SUBJECT: ARKANSAS NUCLEAR ONE, UNITS 1 AND 2 - STAFF ASSESSMENT OF INFORMATION PROVIDED PURSUANT TO TITLE 10 OF THE *CODE OF FEDERAL REGULATIONS* PART 50, SECTION 50.54(f), SEISMIC HAZARD REEVALUATIONS FOR RECOMMENDATION 2.1 OF THE NEAR-TERM TASK FORCE REVIEW OF INSIGHTS FROM THE FUKUSHIMA DAI-ICHI ACCIDENT (TAC NOS. MF3822 AND MF3823)

STAFF ASSESSMENT BY THE OFFICE OF NUCLEAR REACTOR REGULATION

RELATED TO SEISMIC HAZARD AND SCREENING REPORT

ARKANSAS NUCLEAR ONE, UNITS 1 AND 2

Figure 3.3-1 Plot of the Staff's and Licensee's Base Case Shear-Wave Velocity Profiles for the ANO site

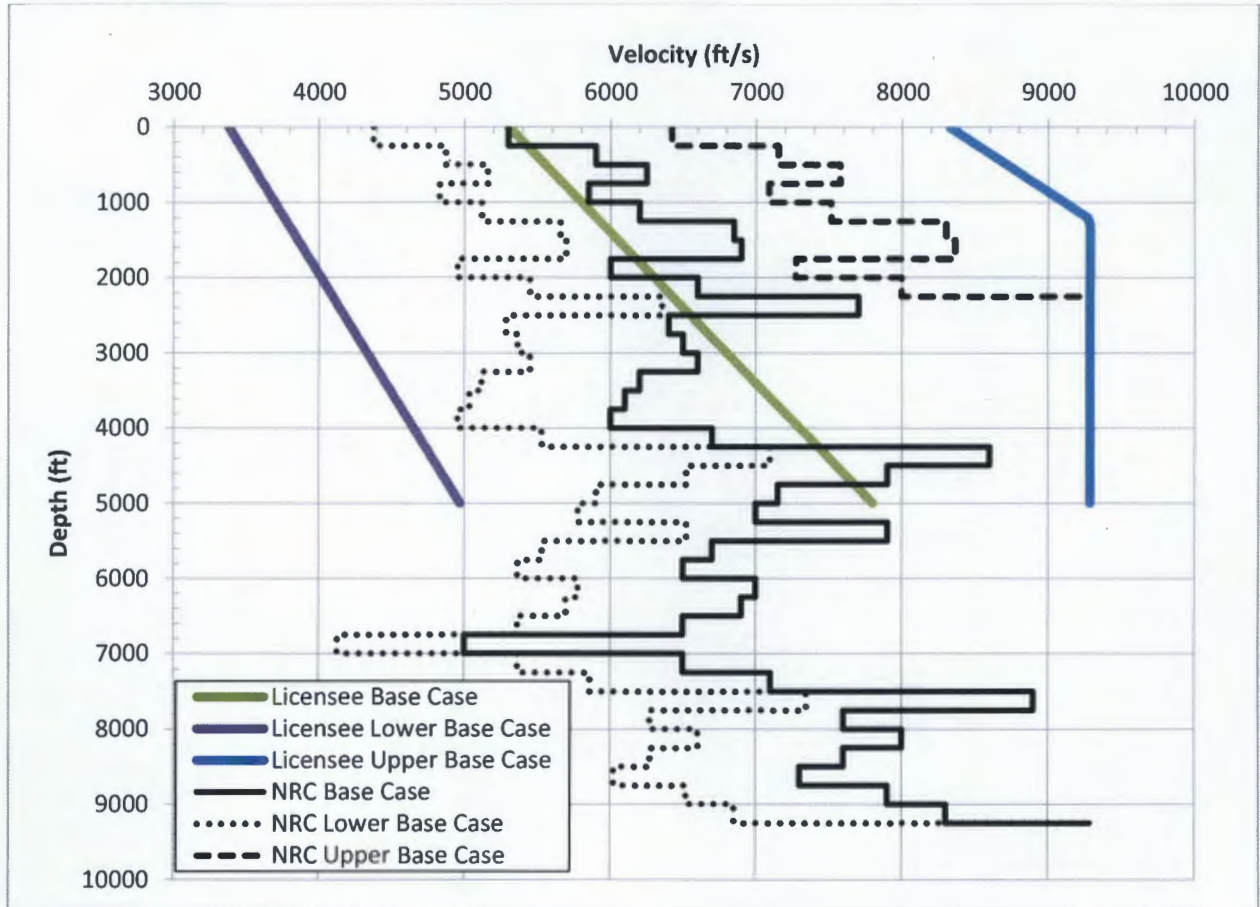
The licensee developed the shear-wave velocities for the base case profile from the compressional wave velocities measured during the original licensing of the plant. The licensee assumed a shallow shear wave velocity of 5,300 ft/s (1,616 m/s) based on assuming a Poisson's ratio of 0.30. Because there are no on-site measurements of shear wave velocities for the deeper layers, the licensee used a velocity gradient of 0.5 m/m/s to develop the shear wave velocities for the lower portion of the base case profile, resulting in a base-case shear wave velocity of 7,772 ft/s (2,369 m/s) at a depth of 5,000 ft. (1,524 m). To capture the uncertainty in the shear wave velocities beneath the site, the licensee developed three base case shear-wave velocity profiles for the ANO site. To calculate the lower and upper base case shear-wave velocity profiles, the licensee used a scale factor of 1.57, reflecting a natural log standard deviation of 0.35. Table 2.3.2-1 and Figure 2.3.2-1 of the SHSR provide the licensee's shear-wave velocity profile for each of the three base cases. Figure 3.3-1 of this assessment shows the licensee's three shear-wave velocity base case profiles.

contains P-wave velocity information to a depth of greater than 10,000 ft. (3,048 m), and NRC staff used this information to develop its base case velocity profile. The NRC staff assumed a Poisson's ratio of 0.28 to convert the P-wave velocity information to shear-wave velocities and smoothed the velocity log by taking the average velocity in each 250 ft. (76 m) interval. To capture the uncertainty in the rock shear wave velocities, the NRC staff used a natural log standard deviation of 0.15 to calculate upper and lower base case profiles. In addition, the NRC staff randomized the depth to reference rock by  $\pm 10$  percent to account for additional uncertainty. Figure 3.3-1 of this assessment shows the staff's three base case velocity profiles compared to the base case profiles developed by the licensee. Overall, the profiles developed by the NRC staff show considerably more variability due to the staff's use of the sonic log data from nearby wells. In addition, the staff's lower base case profile is significantly higher than that of the licensee. However, as discussed below, these differences have a limited impact on the site amplification functions and resulting control point seismic hazard curves.

Figure 3.3- 2 Plot Comparing the Staff's and the License's Median Amplification Functions and Uncertainties for two input loading levels for the ANO site

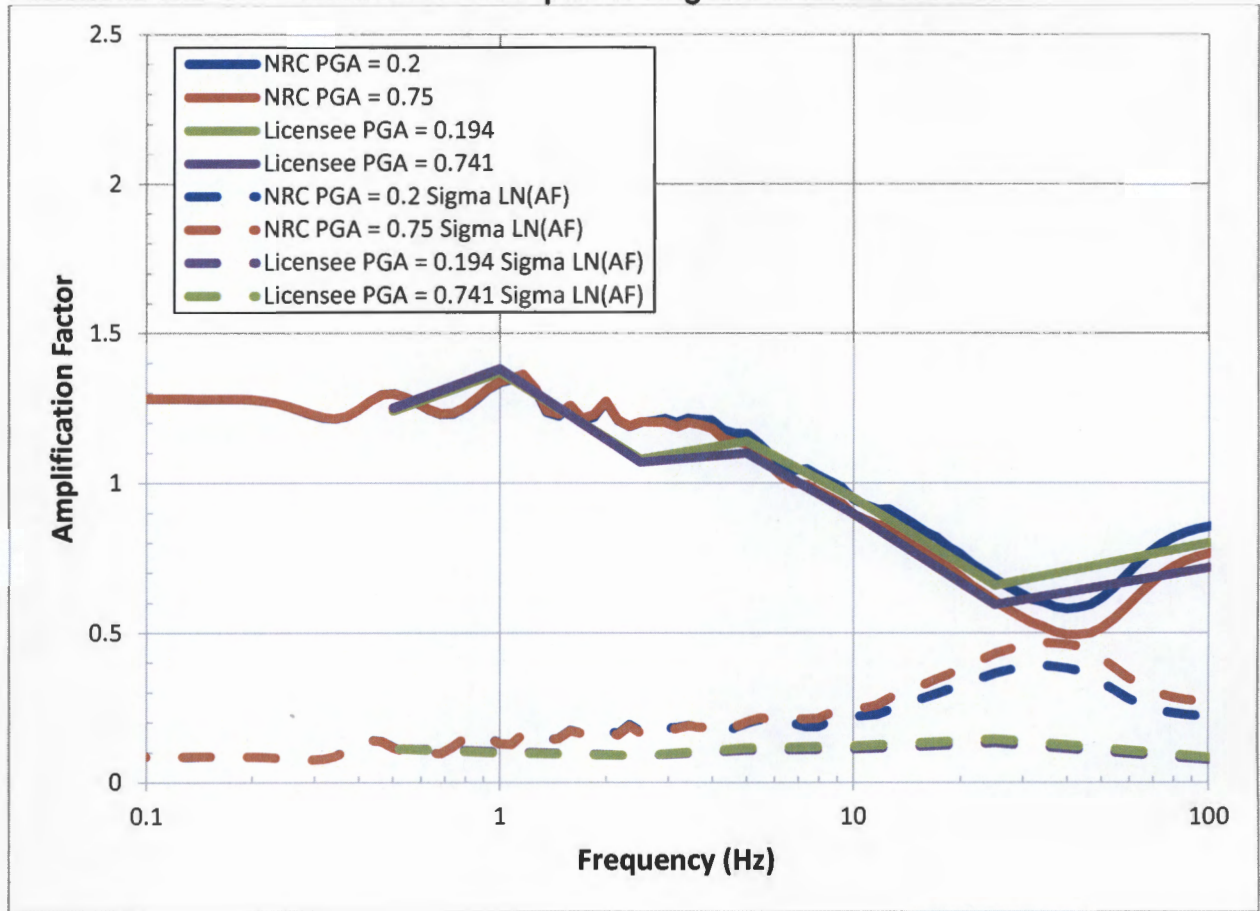
Figure 3.3-2 of this assessment shows a comparison of the staff's and licensee's median site amplification functions and associated uncertainties ( $\pm 1$  standard deviation) for 2 of the 11 input loading levels. The primary peak in amplification occurs at approximately 1 Hz, with a smaller peak occurring at approximately 5 Hz. Amplification functions determined by the NRC staff are similar to those developed by the licensee. Minor differences are due to differences in seismic velocities and the greater depth to reference rock in the staff's profiles.

Figure 3.3-3 Plot Comparing the Staff's and the Licensee's Mean Control Point Hazard Curves at a Variety of Frequencies for the ANO site

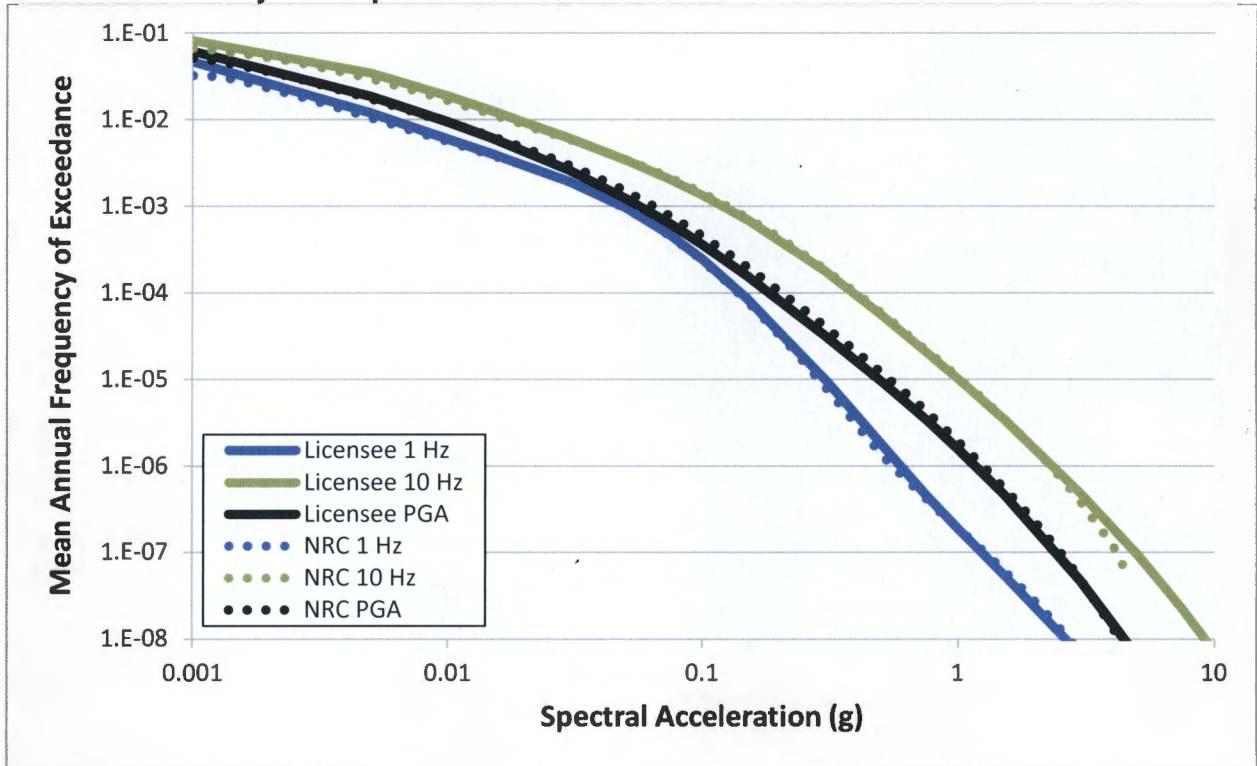
As shown in Figure 3.3-3 of this assessment, these differences in site response analysis have a minor impact on the control point seismic hazard curves and the resulting GMRS, as discussed below. Specifically, at 1 Hz and 10 Hz, the control point seismic hazard curves developed by the licensee are nearly identical to those developed by the NRC staff. Minor differences at PGA are attributed to differences in site response inputs. Appendix B of the SPID provides guidance for performing site response analyses, including capturing the uncertainty for sites with less subsurface data; however, the guidance is neither entirely prescriptive nor comprehensive. As

Figure 3.4-1 Comparison of the Staff's GMRS, Licensee's GMRS, SSE, and the IHS for the ANO site.

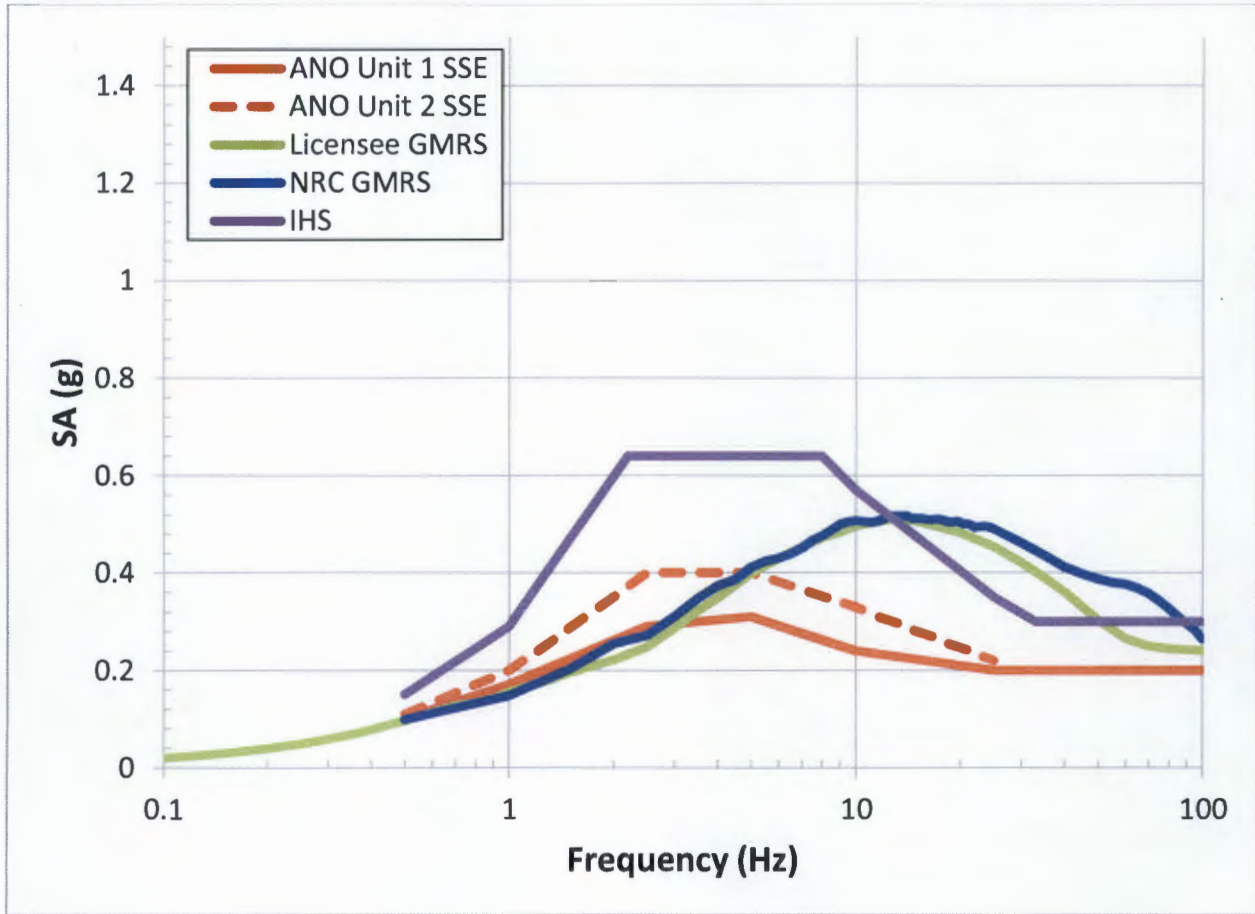
The NRC staff independently calculated the  $10^{-4}$  and  $10^{-5}$  UHRS using the results of its confirmatory PSHA and site response analyses, as described in Sections 3.2 and 3.3 of this staff assessment, respectively. Figure 3.4-1 of this assessment shows a comparison of the GMRS determined by the licensee to that determined by the NRC staff.

As shown in Figure 3.4-1, the licensee's GMRS shape is similar to that calculated by the NRC staff across all frequencies. At frequencies above approximately 15 Hz, the GMRS developed by the NRC staff moderately exceeds that developed by the licensee. As described above in Section 3.3, the staff concludes that these differences over the higher frequency range are minor and primarily due to the differences in the site response analyses performed by the licensee and staff.

The staff confirms that the licensee used the present-day guidance and methodology outlined in RG 1.208 and the SPID to calculate the horizontal GMRS, as requested in the 50.54(f) letter. The staff performed both a PSHA and site response confirmatory analysis and achieved results consistent with the licensee's horizontal GMRS. As such, the staff concludes that the GMRS determined by the licensee adequately characterizes the reevaluated hazard for the ANO site. Therefore, this GMRS is suitable for use in subsequent evaluations and confirmations, as needed, for the response to the 50.54(f) letter.
